**RE: Response to MDE “Questions for Applicant” Letter for
Proposed Chesapeake Terrace Rubble Landfill
Odenton, Maryland
Control Number 1993-WRF-0225**

Provided below are responses to the Maryland Department of the Environment (MDE) “questions for applicant” letter issued to National Waste Managers, Inc. (NWM) on during the week of March 25, 2024 (Doc Control No. 1993-WRF-0225) regarding the Phase III Engineering Plans and Specification Report, and the Phase II Addendum for the proposed Chesapeake Terrace Rubble Landfill.

This document has been prepared in a comment and response format, with your questions/request followed by the NWM response in bold. Attached to this letter are

Drawing 27 – Leachate Control Panel Layout

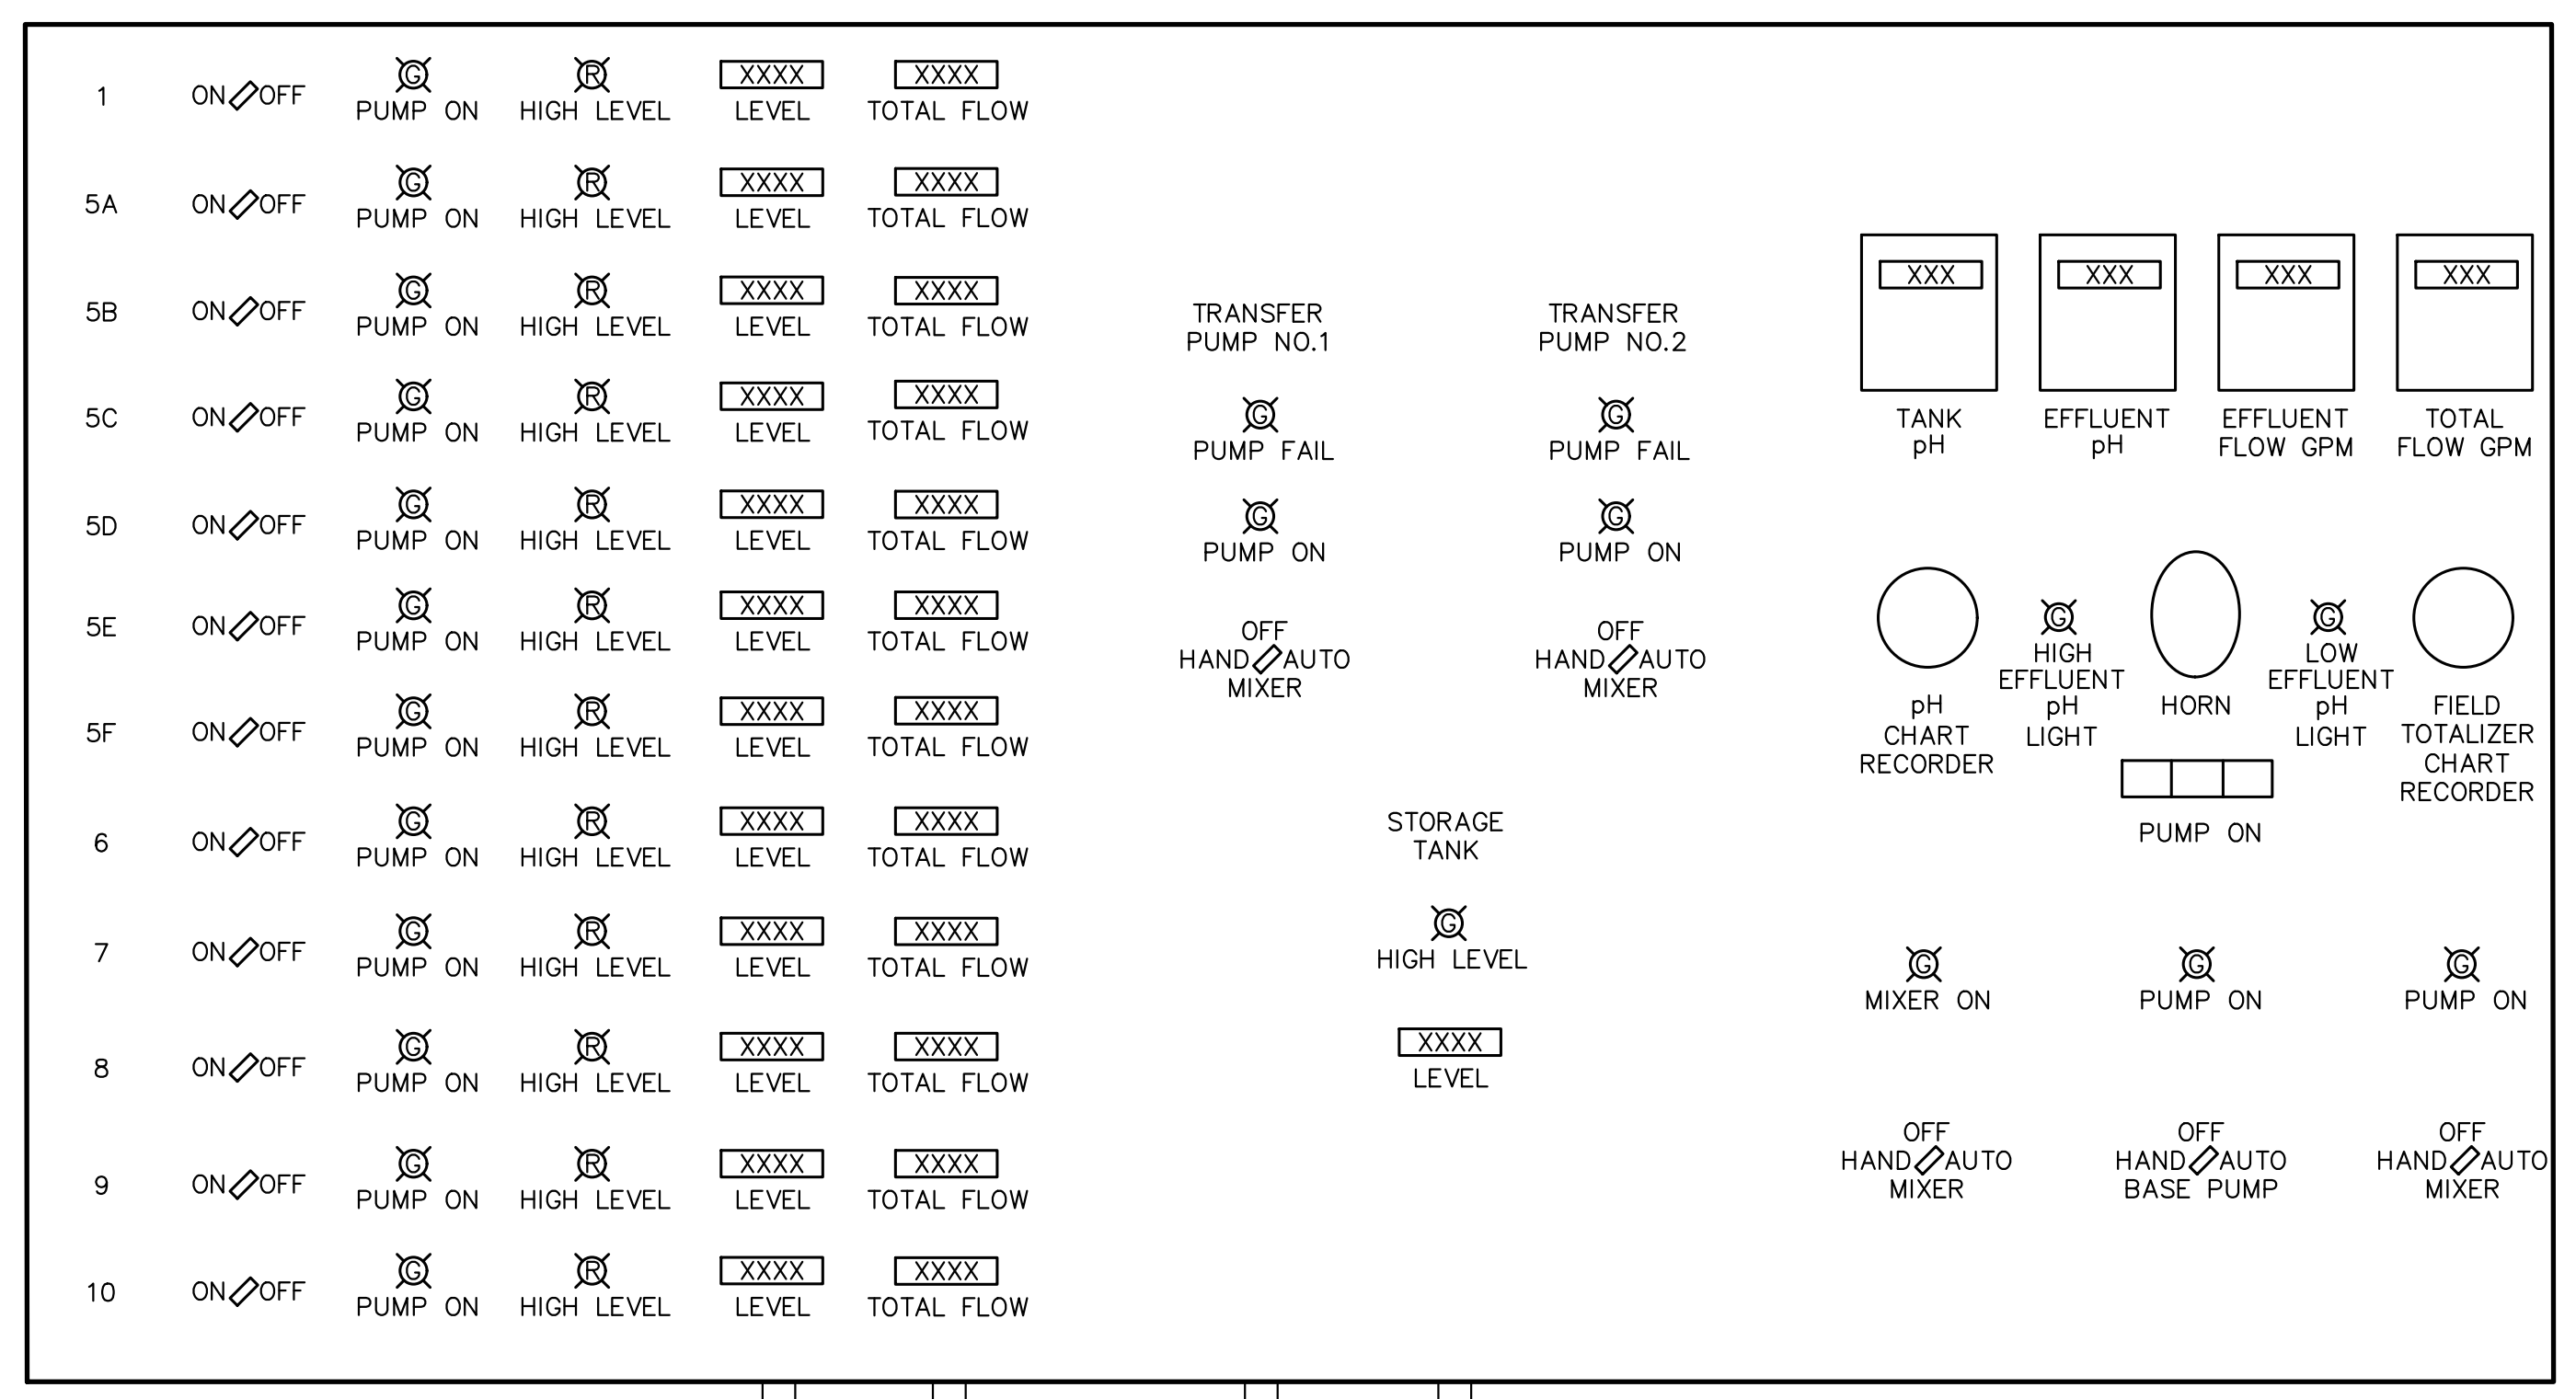
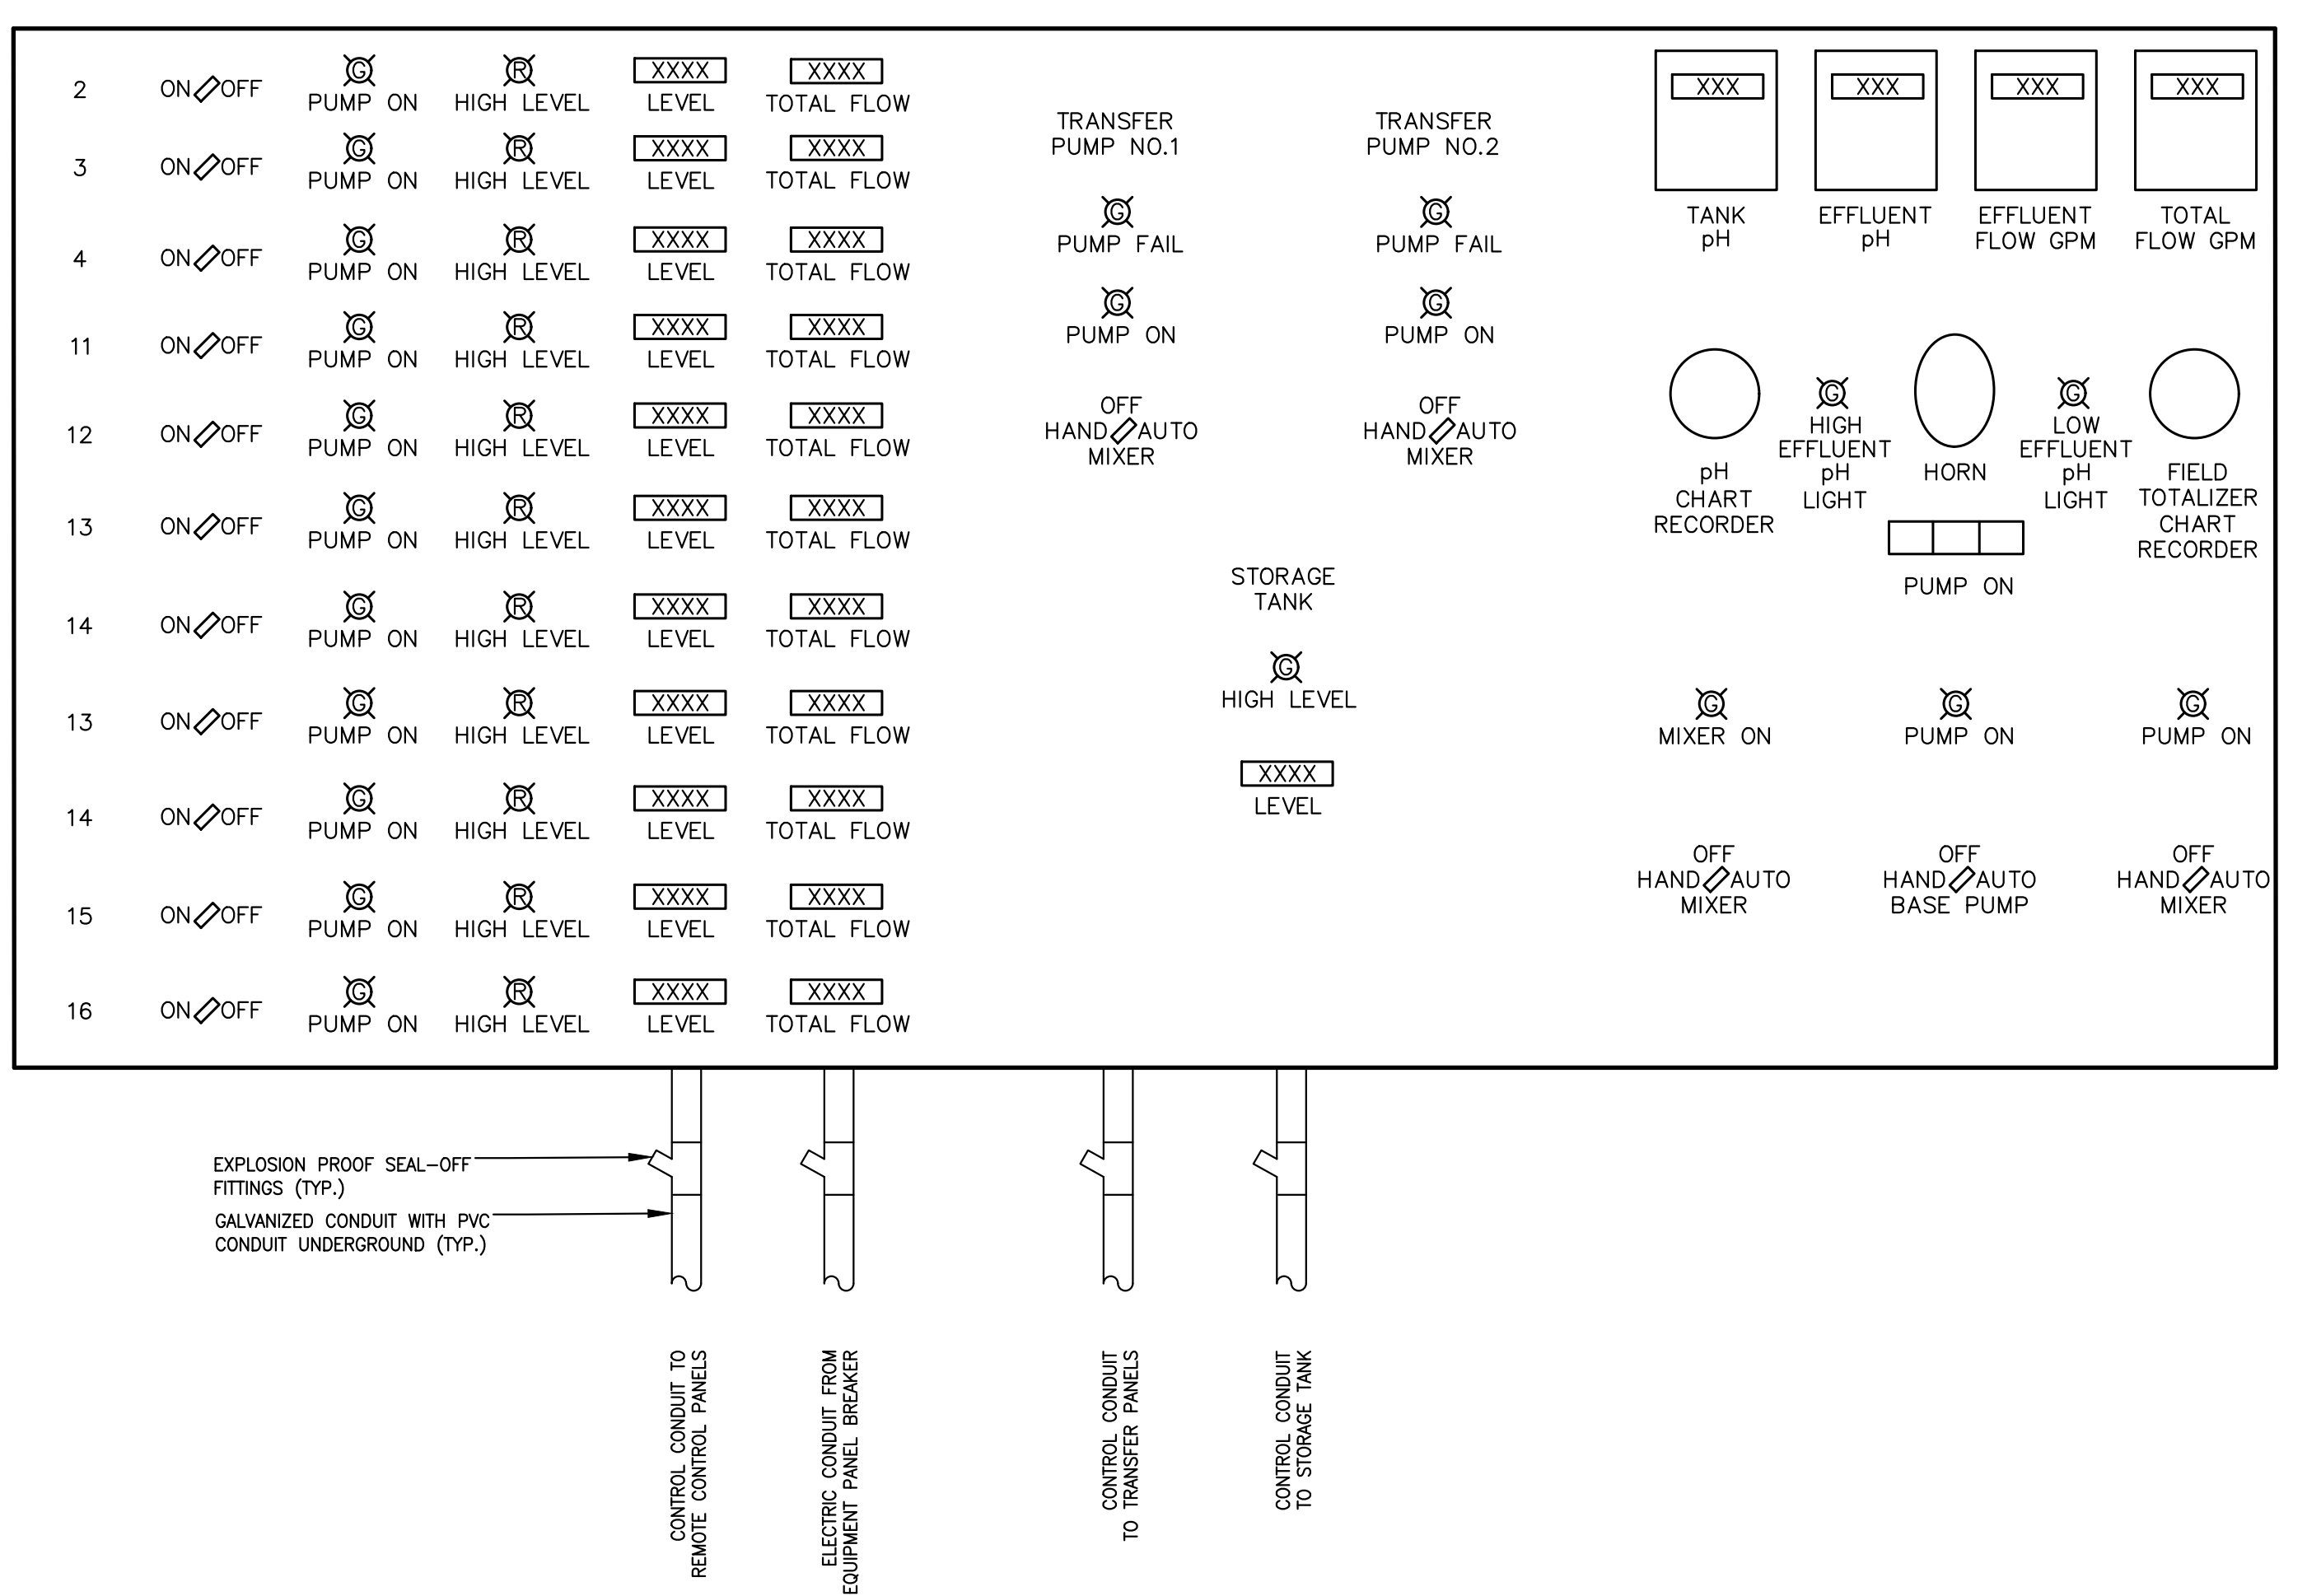
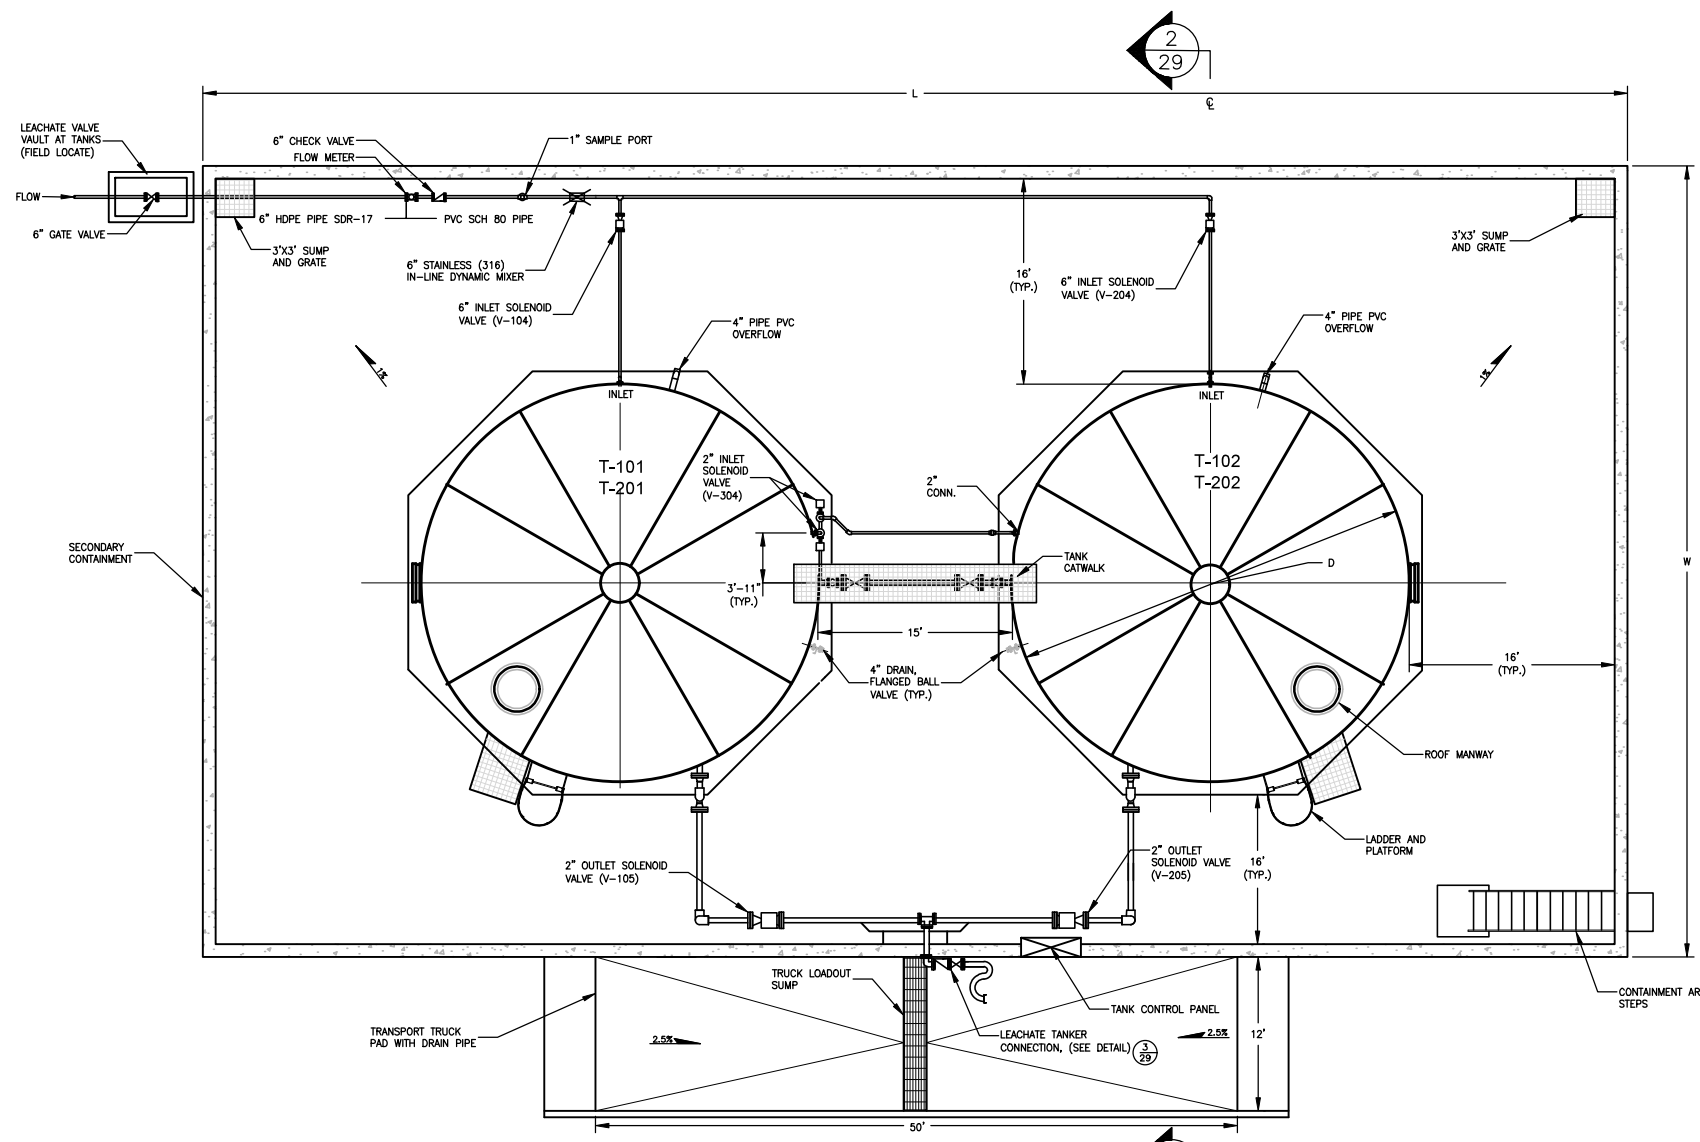
10. **MDE Comment:** Section 10.4 Leachate Pumps states "As shown on the "Cell Pump List" on Drawing 27 and in Section 10.9.3, one pump in each cell sump is sufficient to remove leachate under the peak daily generation scenario, described further in Section 10.9. A spare pump will be provided during construction of each cell for storage in the associated Leachate Pump House for immediate installation when the installed pump needs annual servicing or malfunctions." MDE requires two pumps in a sump for the low flow/high flow conditions and for redundancy. Please correct the design to include two pumps per cell.

12. **MDE Comment:** Please clearly demonstrate in Appendix 10F Leachate Pump Sizing Calculations the head loss through the flexible pump discharge hose and couplings and other transitions, fittings, and valves in the hydraulic calculations. Currently, only the friction loss through the 6-inch force main is provided.

NWM Response: We have modified the text in Section 10 to state that as required by MDE duplicate pumps shall be installed in each sump. This does not require modification of the design as all sumps were designed to accommodate 2 pumps. A complete copy of the revised Section 10 "Leachate" text is attached to this letter.

NWM Response: The Leachate Pump Sizing Calculations in Appendix 10F have been revised to include the friction loss through the 2" line from the bottom of the leachate sump to the connection with the 6" carrier pipe. We have accounted for the head loss through the various elbows and connections in both the 2" and 6" lines utilizing the Crane Co. Technical Paper 409 Equivalent Pipe Length Technique (Based on Hazen-Williams Formula) where various connections and valves are assigned an equivalent pipe length that is subsequently added to the pipe lengths when calculating friction loss. The resulting calculations, shown in the revised Appendix 10F Table (attached to this letter as Response to Comment 12), prompted an increase in the pump sizes for Sumps 9, 10, 13, 14 and 16. In addition to the Table in Appendix 10F, the design head and/or model of the pumps appear in Drawing 27 and Table 5 in Section 10.9.3. The revised Drawing 27 and copy of the revised Text for Section 10

"Leachate" are attached to the response to comments letter.

Drawing 28 – Leachate Storage Tank Details (1 of 2)

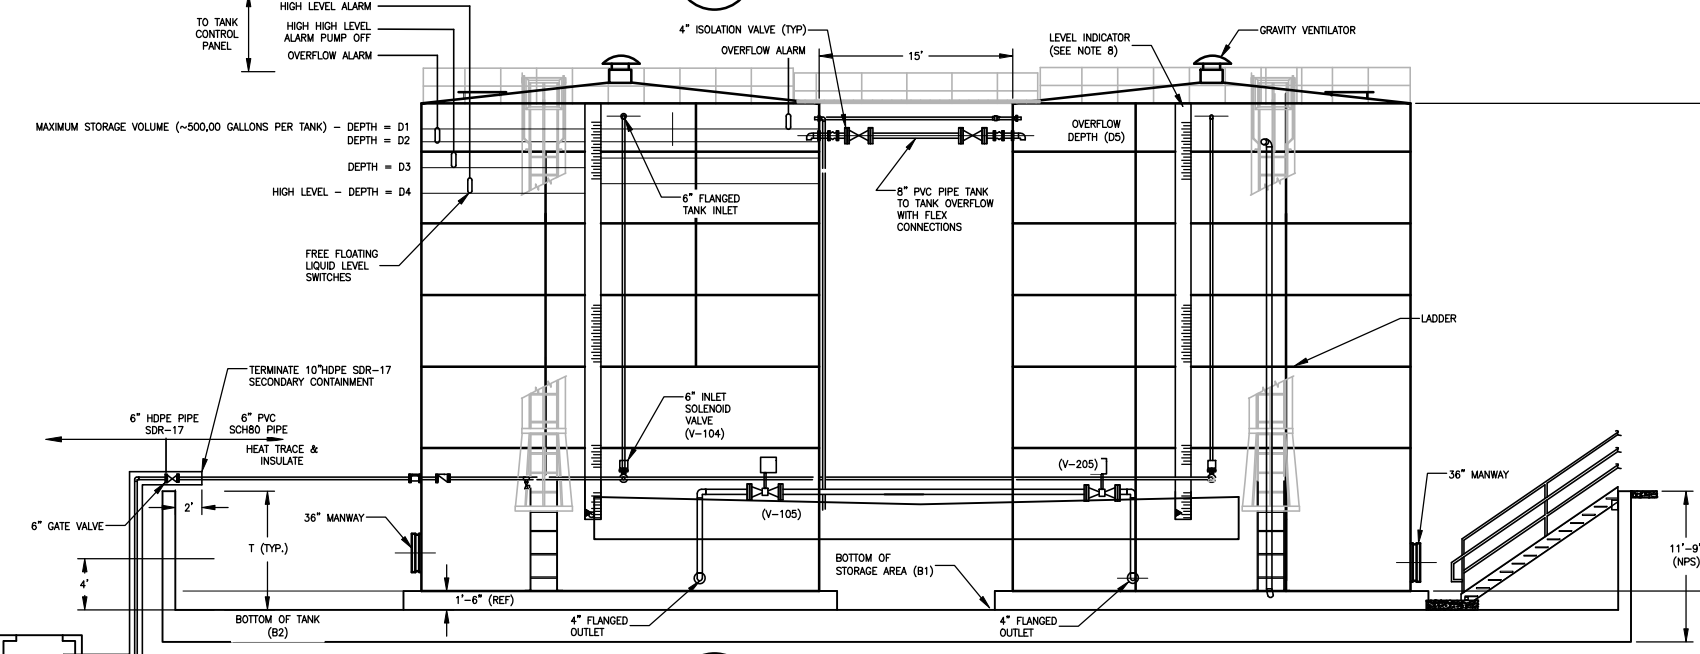
18. **MDE Comment:** Please address how odor will be controlled at the leachate tanks.

NWM Response: We have added an in-line dynamic mixer to the leachate inflow line inside the leachate tank containment area between the 1-inch sample port and the 6-inch solenoid valves (see Drawing 28). The chemical inflow line to the mixer will be capped when initially installed but when/if tank odor becomes a problem the mixers will be utilized to feed an oxidant into the leachate lines before the discharge to the tanks. The specific type of oxidant will be determined based on the source of odors, but expectations are that any significant odor concerns will be sulfur based (hydrogen sulfide, mercaptans, or disulfides) and that the most logical oxidant will be H₂O₂, permanganate or a proprietary compound. Dosing rates will also be a function of the oxidant utilized, concentrations present in the leachate and flow rates. These are typically addressed through a combination of head space testing (in the tanks) and monitoring the effect from different dosing rates. We added text to Section 12.12.1.2.2. A complete copy of the Section 12 "Operations Plan" text is attached to this letter.
